MODIFICATION RECOMMENDED

N5244A-03

N5244A PNA Series Microwave Network Analyzers

July 16, 2012

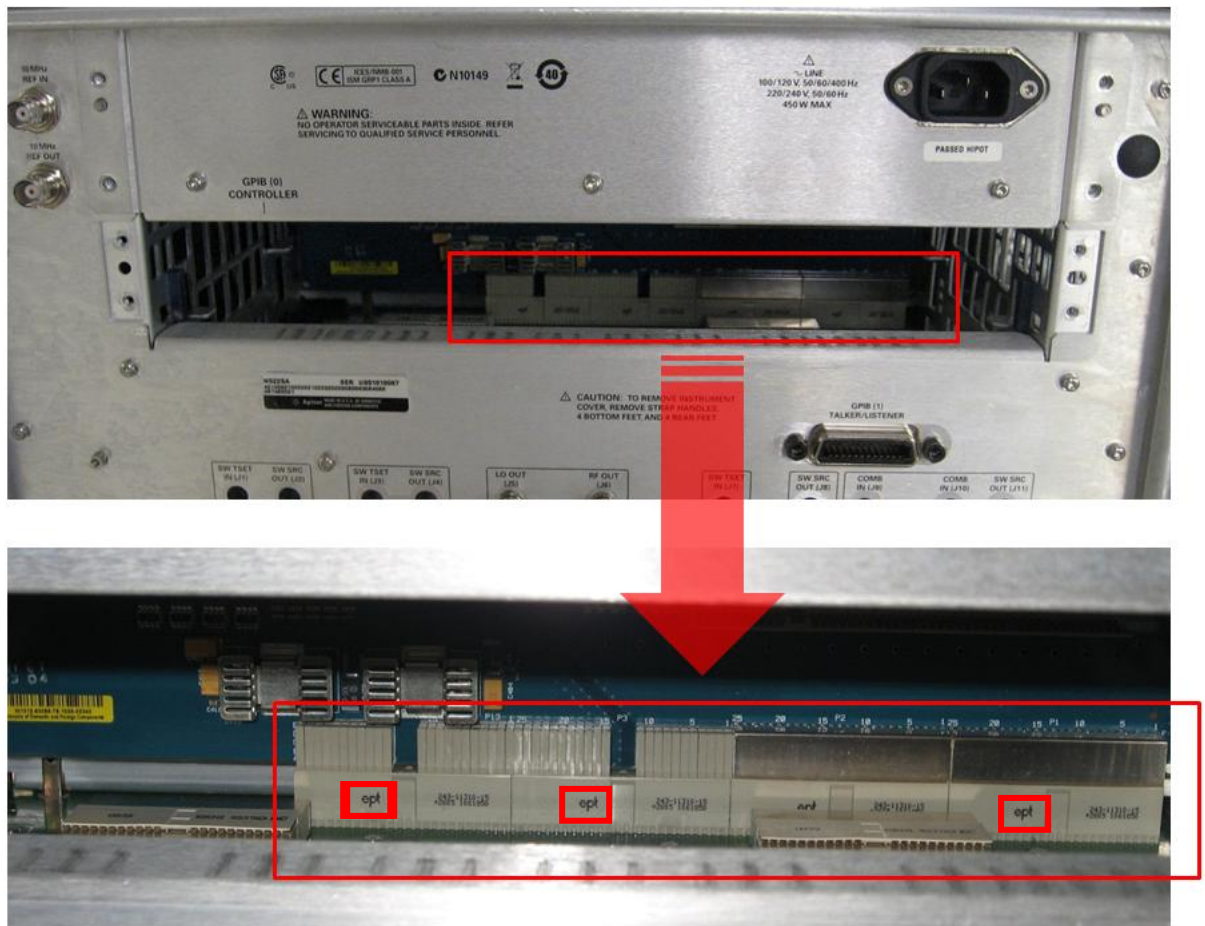
1. Remove the CPU assembly from the analyzer's rear panel. Refer to the PNA Service Guide chapter 7 section titled, "Removing and Replacing the CPU Board Assembly" for removal and reinstallation procedures. To view the online Service Guide, see the numbered list on the next page for instructions.
2. As per the photo below, inspect the system motherboard connector to see if it has one or more "ept" logos.

3. If the connector has one or more “ept” logos, return the analyzer to Agilent for replacement of the system motherboard. If the connector does not have one or more “ept” logos, email support_ctd-soco_support@agilent.com, providing the analyzer model and serial number and details of the malfunction symptoms.

4. *For Agilent Service Technicians only:* Only new boards without “ept” logos should be installed. Before installing the new board, look to see if it has one or more “ept” logos. If so, email support_ctd-soco_support@agilent.com, providing the analyzer model and serial number. Wait for further instructions in an email reply. New boards without “ept” logos can be installed.
For installation instructions, refer to the PNA Service Guide chapter 7 section titled, “Removing and Replacing the System Motherboard.” To view the online Service Guide, see the numbered list on the next page for instructions.
